Version 8.3.2 - What's New?

WFRC / MAG

Figure 1: Lane Change between 2019 and 2050 for Model v8.3.2 2022-02-04.

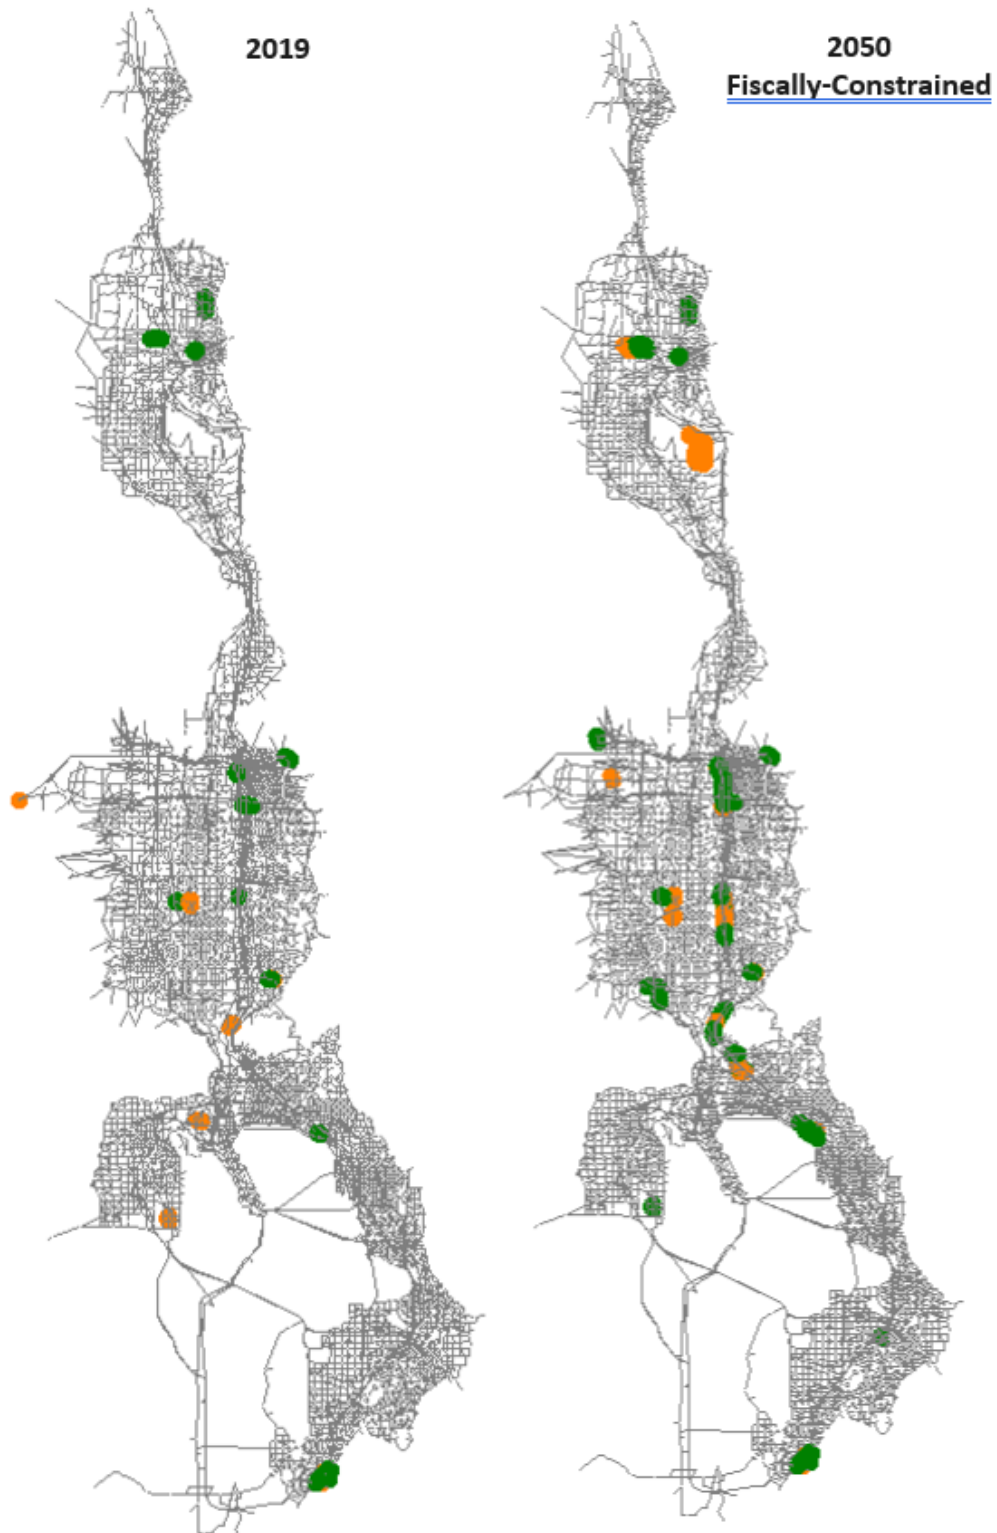
The highway network was updated in the MAG and WFRC areas to reflect the third round of Regional Transportation Plan (RTP) amendments. Additional edits were made in the MAG area to conform with more recent project clarification. Figure 1 shows where lanes were added (green) or were taken away (orange) between versions 8.3 and 8.3.1 highway networks.

Figure 2: Change in Transit Speeds for LRT in Salt Lake County. Green: Increase in Speeds
— Red: Decrease in Speeds.

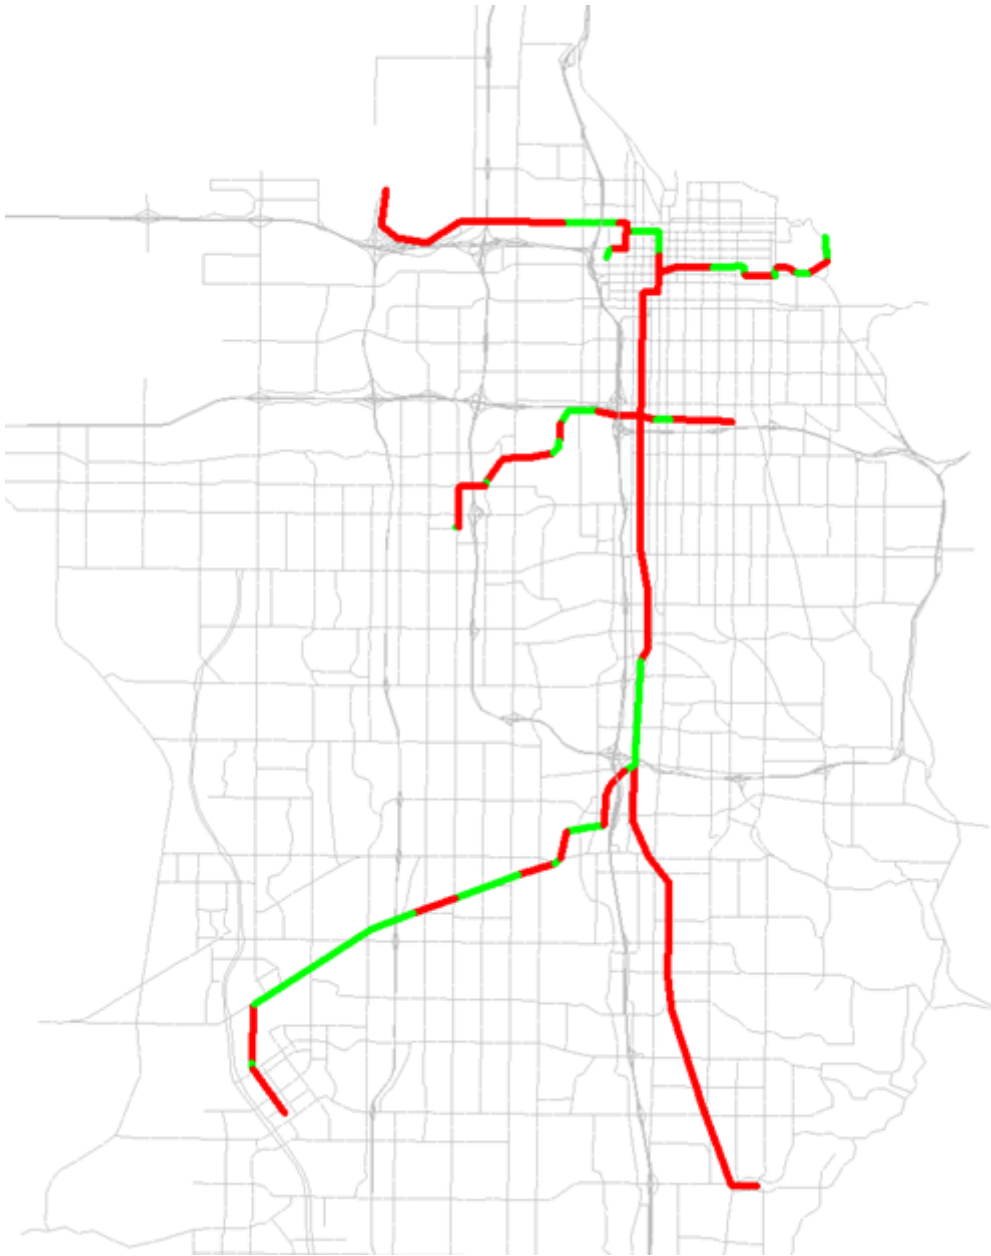
The speed of rail transit is coded onto rail-only links within the master highway network. Transit speed for LRT were updated to reflect 2019 operations. Most of the speed changes were less than 5 mph. Figure 2 shows where light rail speeds were changed.

tbl-lrt-speed shows the resulting average speeds along entire light rail routes. The net effect of the update was generally lower speeds, with the TRAX-Blue line and the S-Line having the largest drops in speed with a drop of 8.2% and 14.5%, respectively.

Figure 3: Hand-Coded Walk Access Links.

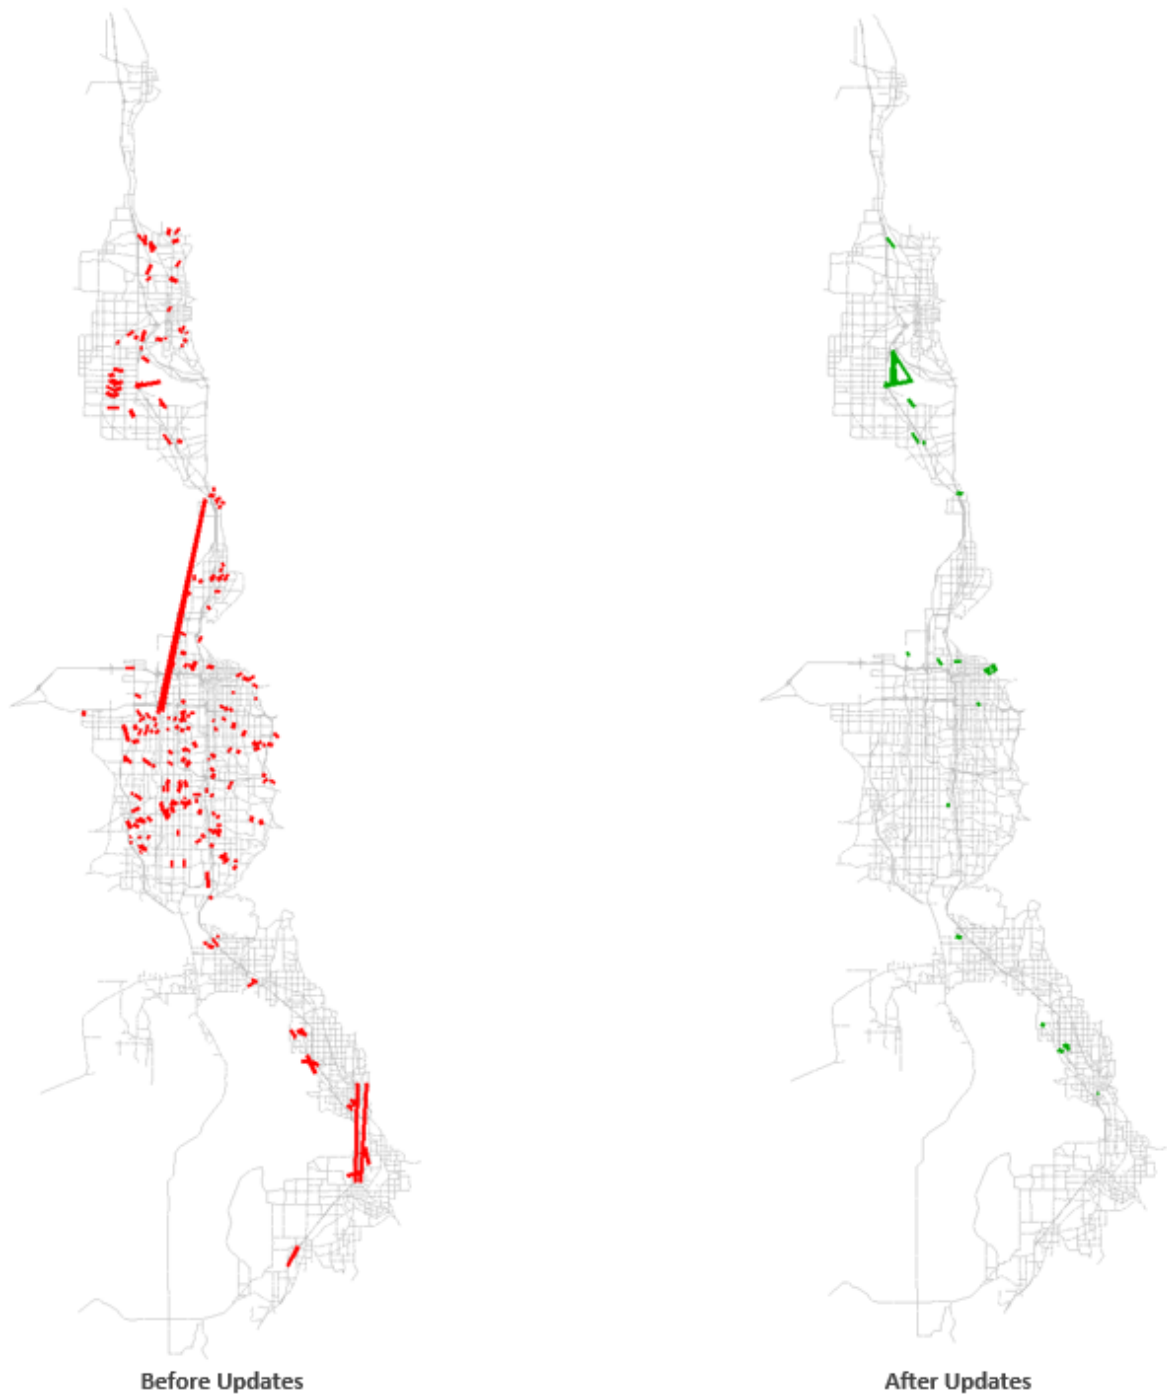
The update process removed a majority of the general hand-coded walk access links, reducing the number from 234 to 31 links. Areas that retained or added hand-coded links include SLC

International Airport, Hill Air Force Base, University of Utah, and Utah Valley University. Figure 3 shows hand-coded walk-access links before and after the updates.

Figure 4: Park-And-Ride Lots. *Red: Removed* — *Green: Added* — *Blue: Modified*

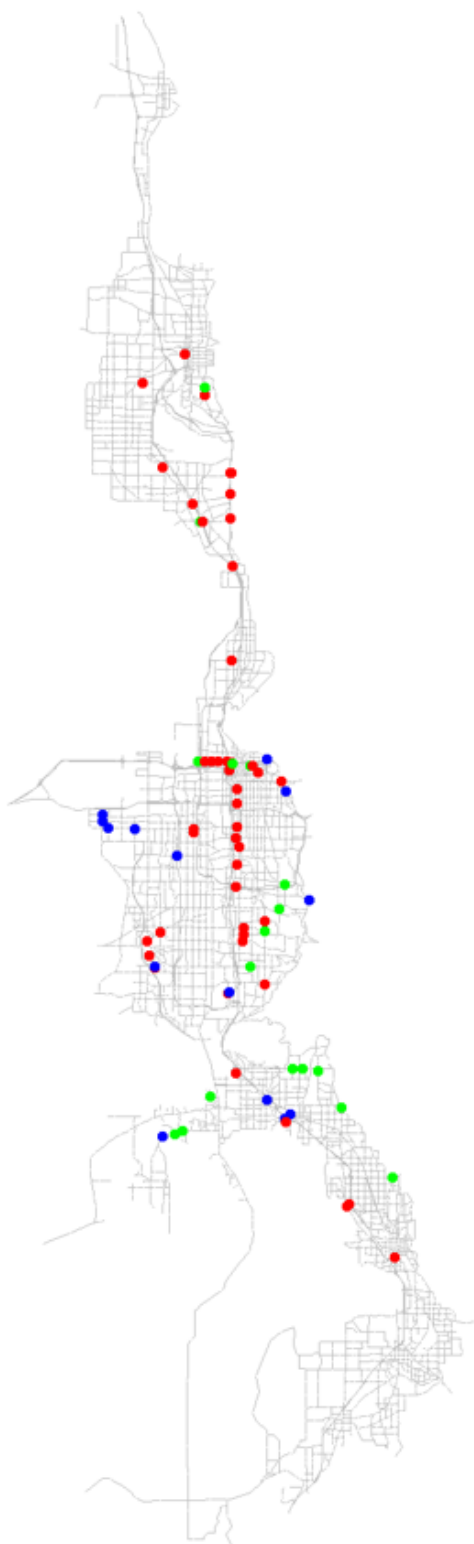
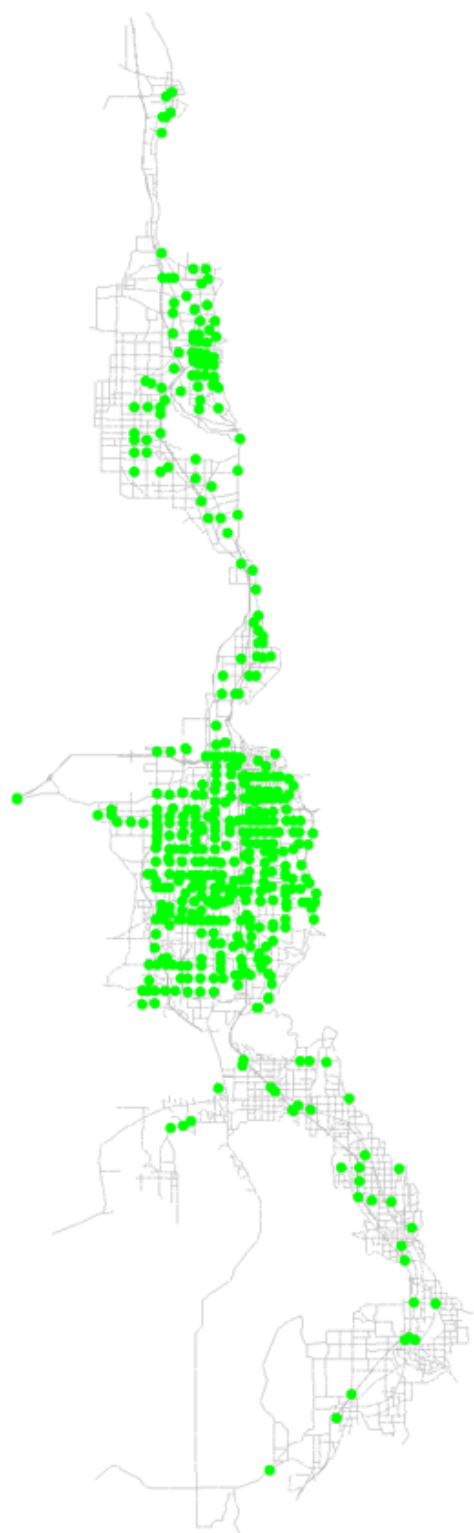
Park-and-Ride lots are coded onto nodes within the master highway network and are defined by what transit mode they service. To be used by the travel model, park-and-ride nodes need to be coded at nodes that serve as rail or bus stops. Figure 4a shows what changes were made to park-and-ride lots, which include 17 additional locations, 49 removed locations, and 14 locations that were modified by changing the mode they service. Most of the park-and-ride lots removals were due to redundancy on highway nodes adjacent to another park-and-ride lot at a rail node. The park-and-ride lots additions mostly included new lots along express bus routes. The resulting park-and-ride lot locations, including ones that were not edited, are shown in Figure 4b.
